City of Portland, Oregon
Bureau of Development Services
Land Use Services

NOTICE OF A TYPE II DECISION ON A PROPOSAL IN YOUR NEIGHBORHOOD

CASE FILE NUMBER: LU 09-104171 DZ – CHANGES TO THE DESIGN OF THE PARK AVENUE WEST TOWER

Park Avenue (East) Elevation - updated

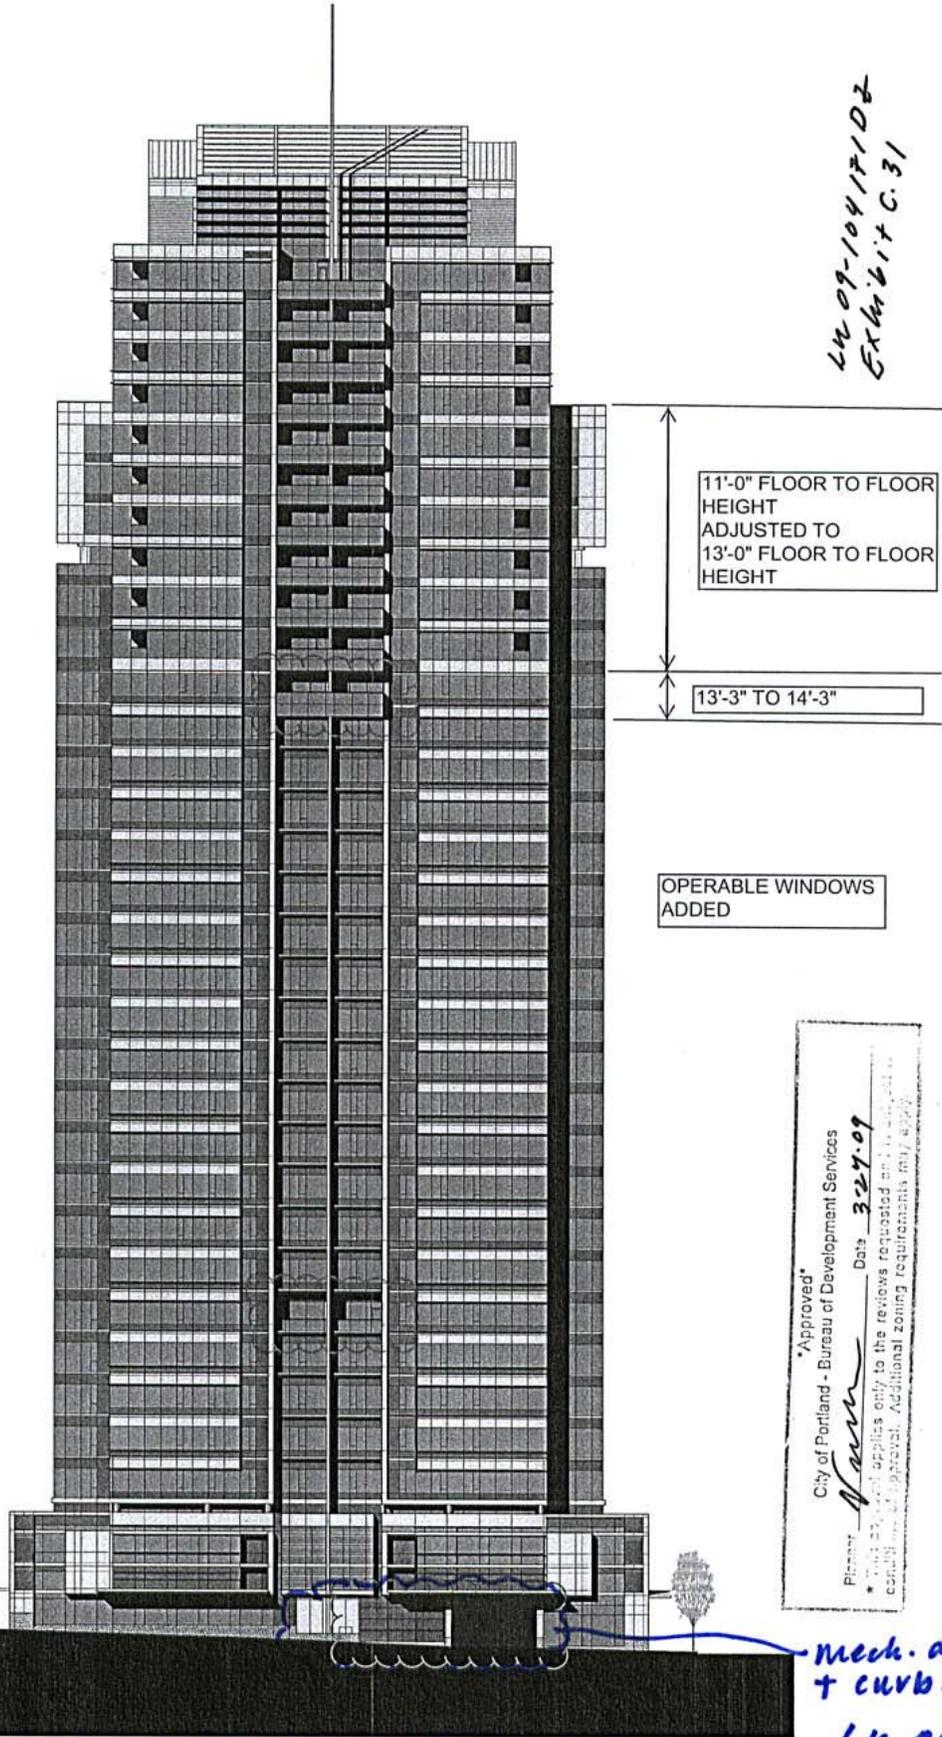
mech. doors added + curbcut widened

Ninth Avenue (West) Elevation - updated

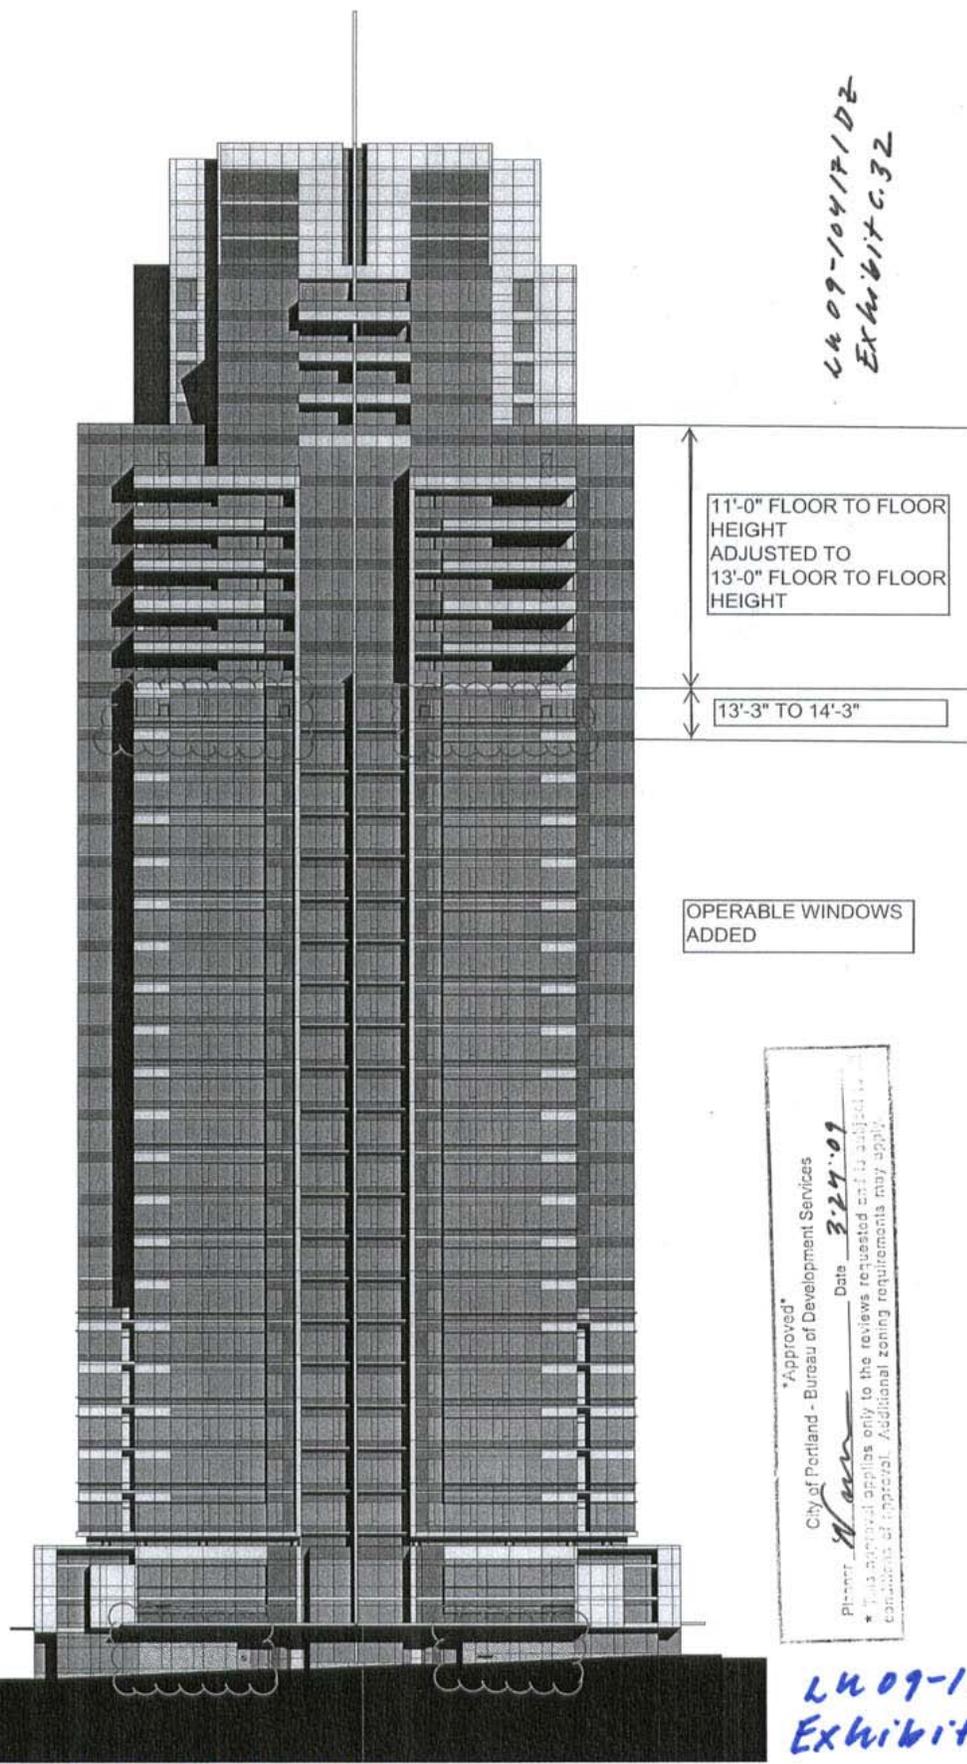
11'-0" FLOOR TO FLOOR
HEIGHT
ADJUSTED TO
13'-0" FLOOR TO FLOOR
HEIGHT

13'-3" TO 14'-3"

OPERABLE WINDOWS
ADDED
